**Update for Subsequent License
Renewal: WCAP-15338-A, “A Review
of Cracking Associated with Weld
Deposited Cladding in Operating
PWR Plants”**

U.S. NRC SAFETY EVALUATION

March 30, 2020

SUBJECT: FINAL SAFETY EVALUATION BY THE OFFICE OF NUCLEAR REACTOR REGULATION FOR THE PRESSURIZED WATER REACTOR OWNERS GROUP TOPICAL REPORT PWROG-17031-NP, REVISION 1, "UPDATE FOR SUBSEQUENT LICENSE RENEWAL: WCAP-15338-A, 'A REVIEW OF CRACKING ASSOCIATED WITH WELD DEPOSITED CLADDING IN OPERATING PWR PLANTS'" (EPID L-2018-TOP-0022)

Figure 1. K_{Ic} Curve with 200 $\text{ksi}\sqrt{\text{in}}$ Upper Shelf

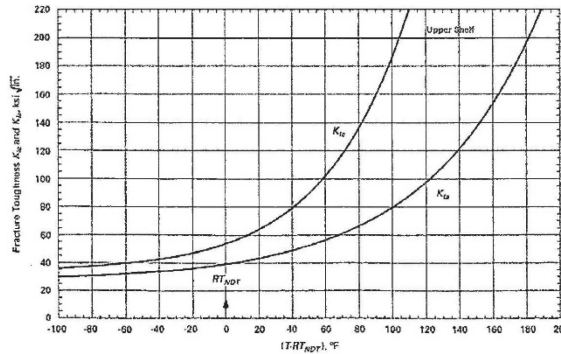
Sections 5.5 and 5.6 of the TR address continued implementation of the same allowable flaw sizes that were previously established for 60-year applications in WCAP-15338-A (October 2002, ML083530289). This is based on consideration of the same governing transient characteristics for 3-Loop plants, as well as the continued use of time-invariant upper shelf fracture toughness (K_{Ic}) of 200 $\text{ksi}\sqrt{\text{in}}$ for all transient analyses.

PWROG-17031-NP [2] and WCAP-15338-A [1] calculate K_{Ic} , fracture toughness per ASME Section XI, Appendix A, A-4200. It is noted that K_{Ia} was not used in the underclad cracking evaluation. Since there is no prescribed upper limit in the ASME code, 200 $\text{ksi}\sqrt{\text{in}}$ was conservatively used as a maximum value (or "upper shelf"), even if the calculated K_{Ic} is higher per the ASME Section XI, Appendix A, A-4200 formula. See Figure 1 for a visual demonstration of the 200 $\text{ksi}\sqrt{\text{in}}$ value superimposed on the ASME Section XI, Appendix A K_{Ic} curve.
